Service Bulletin SB-0025

Subject: Wire Routing Improvements

Effectivity: K003 – K021

Affected Model(s): E1000, E1000 GX

a. Instrument Panel – Left and Right Circuit Breaker Panels

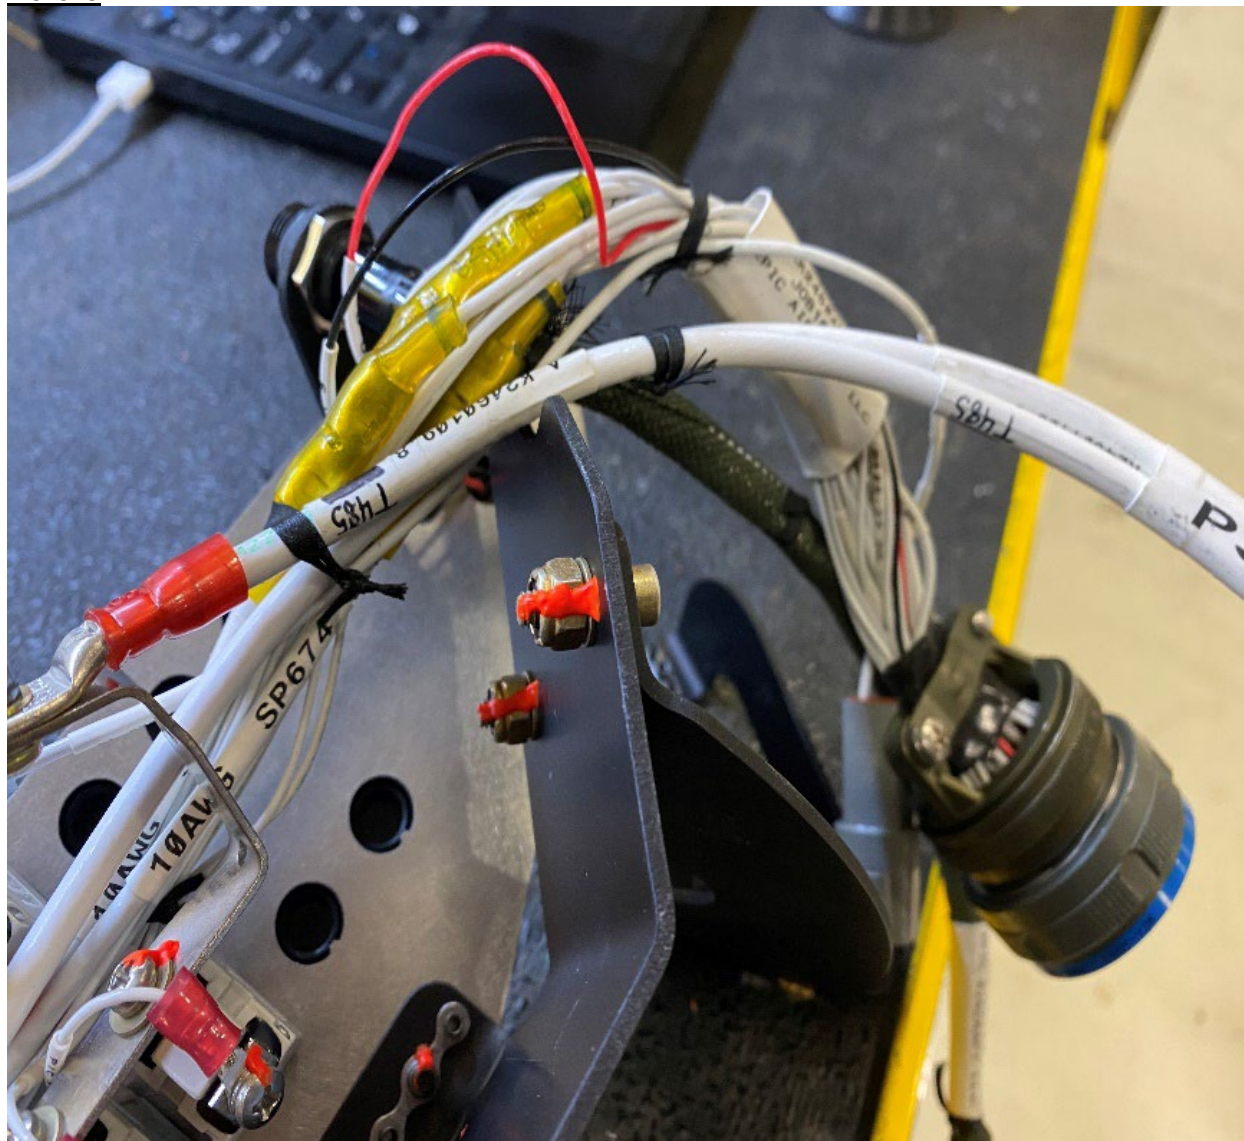
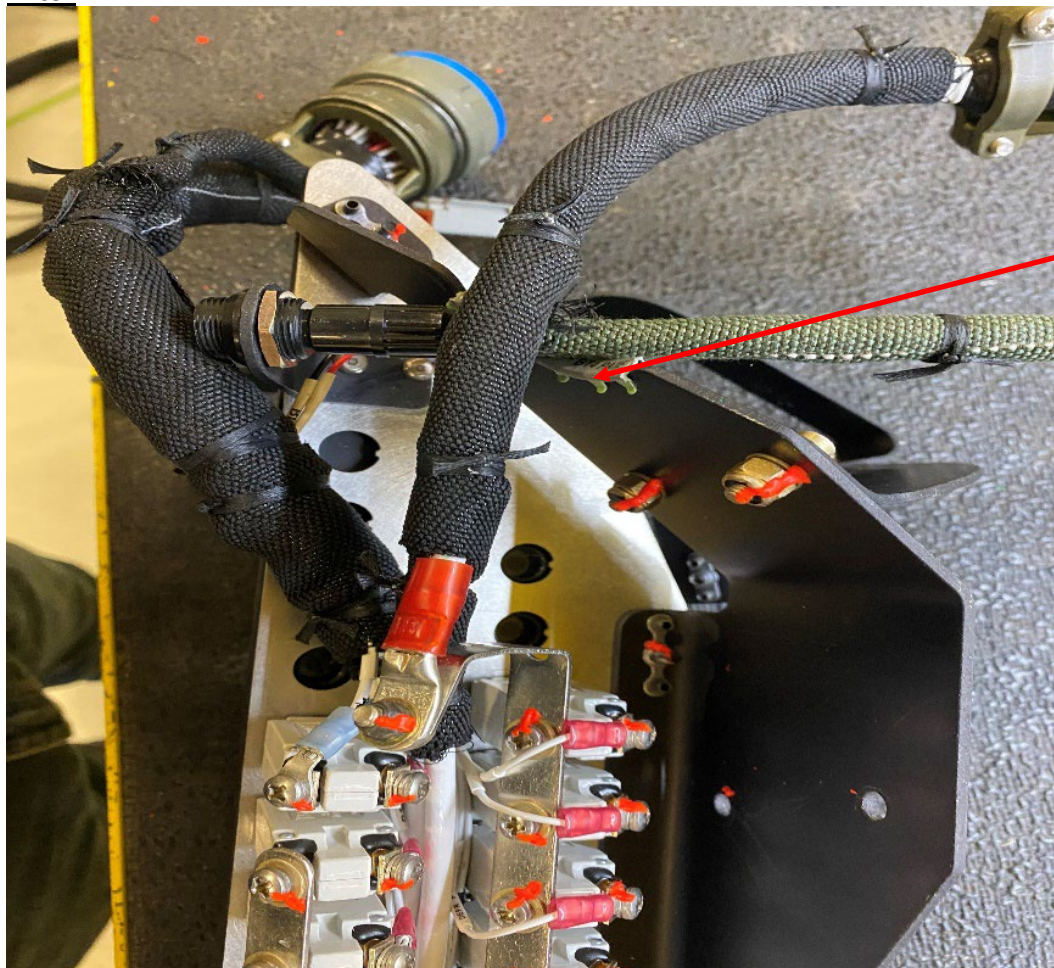
Action: Add Roundit to exposed bare wires; Add edge protection to sharp metal edges to protect wire(s) to prevent chafing.

Chafe hazard.

Add edge protection here.

b. Instrument Panel - Left and Right Circuit Breaker Panels

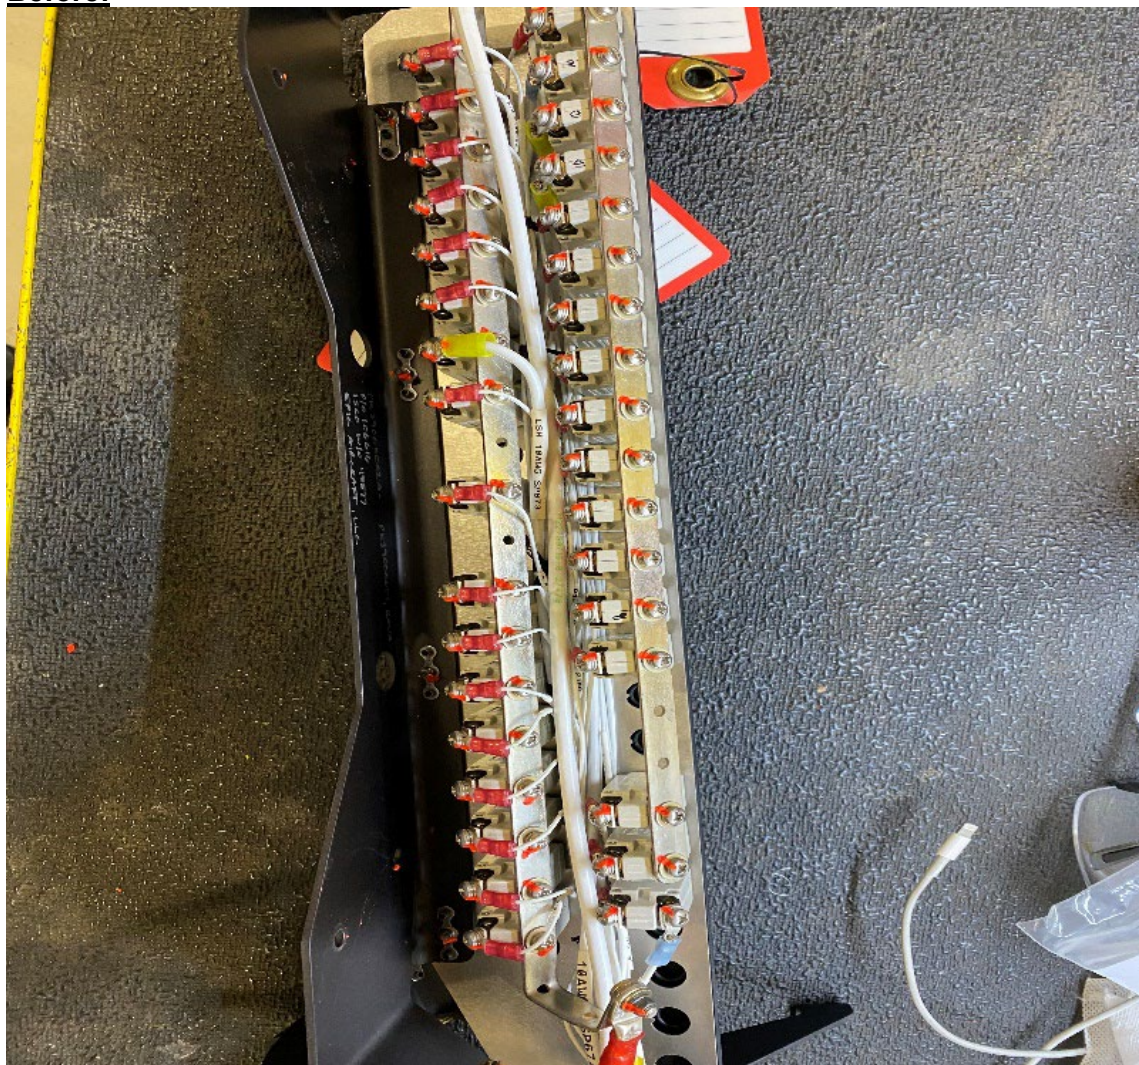
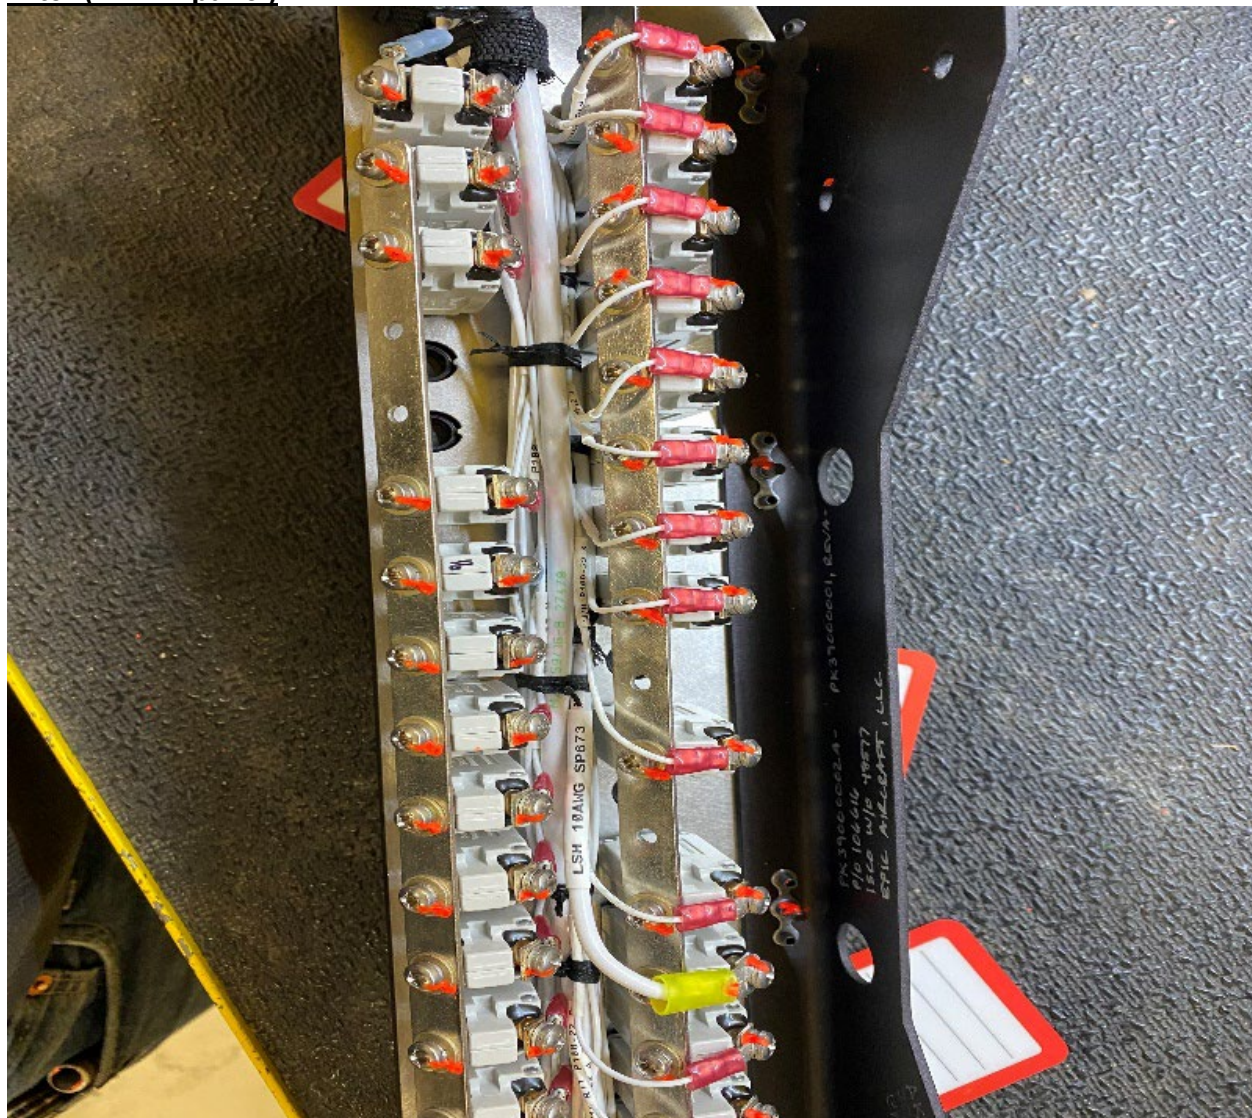
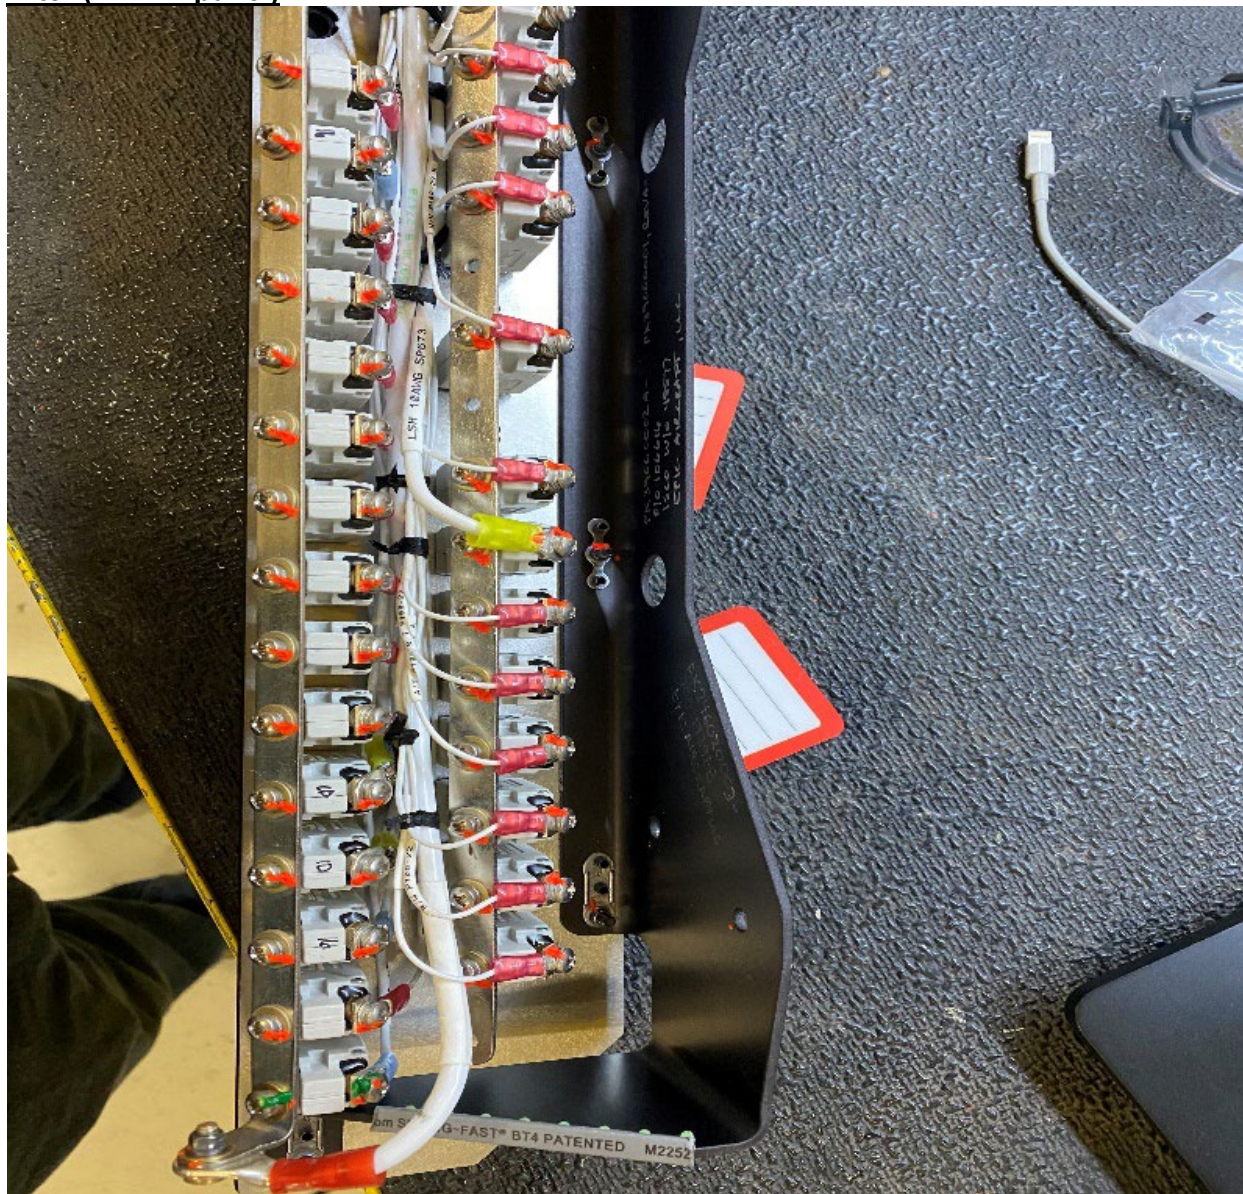
Action: Bundle loose wires using tie string in several locations.

c. Instrument Panel - Left and Right Circuit Breaker Panels

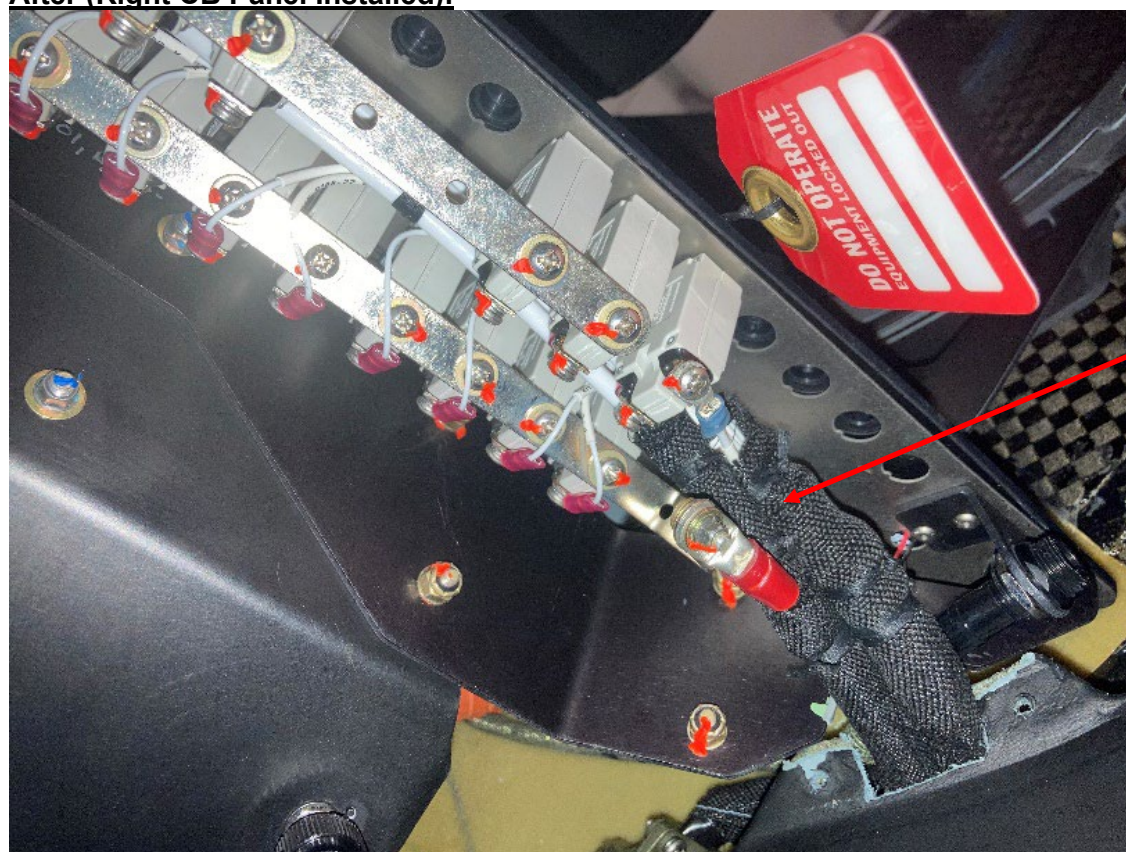
Action: Install Roundit on right circuit breaker panel wiring.

Install Roundit.

d. Underfloor – Ground Wires

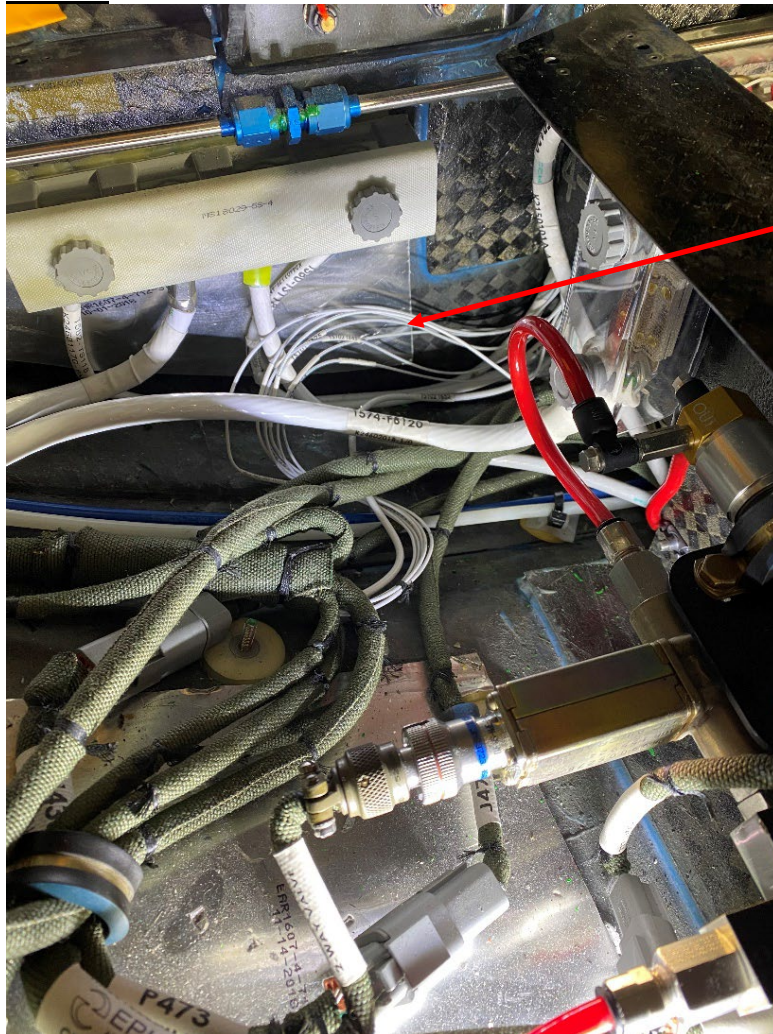
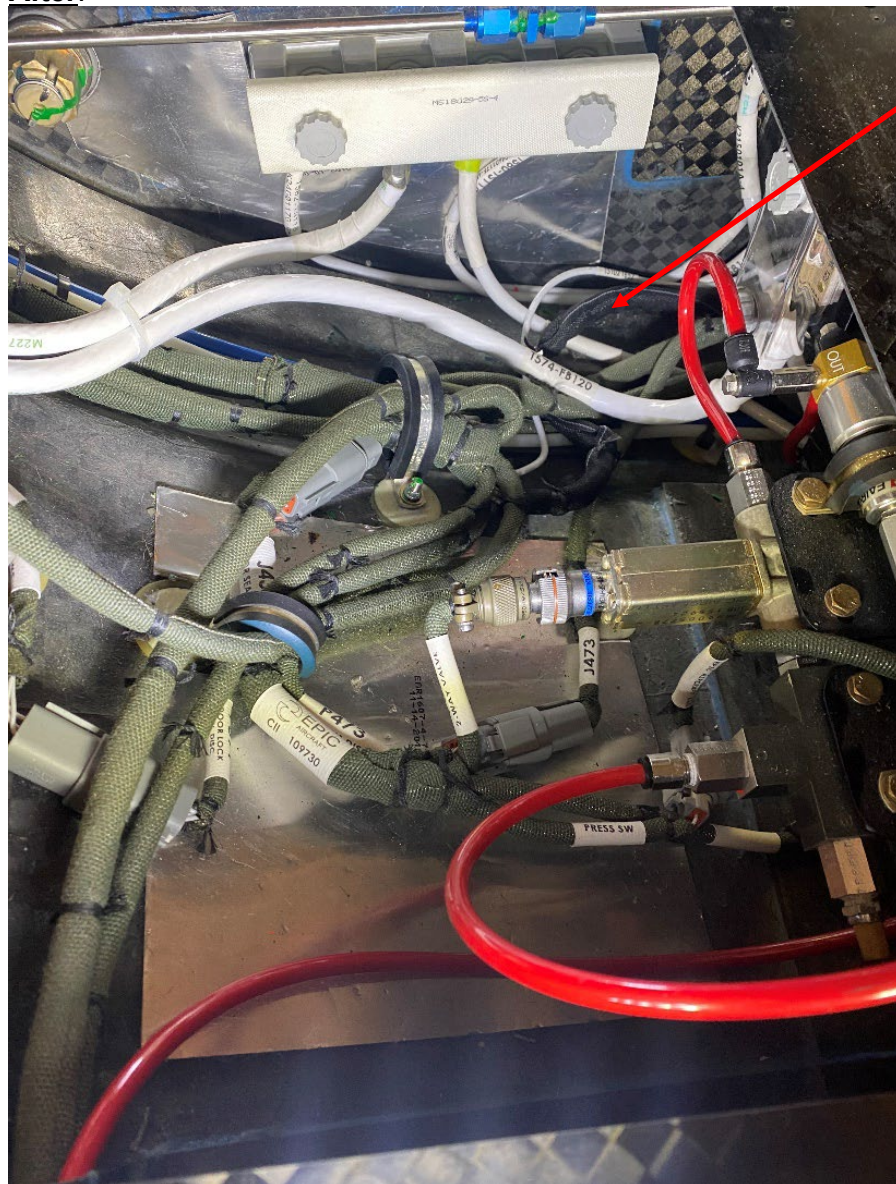
Action: Bundle and install chafe protection on loose ground wires going to ground block TS101 & TS102.

Loose ground wires.

Install Roundit.
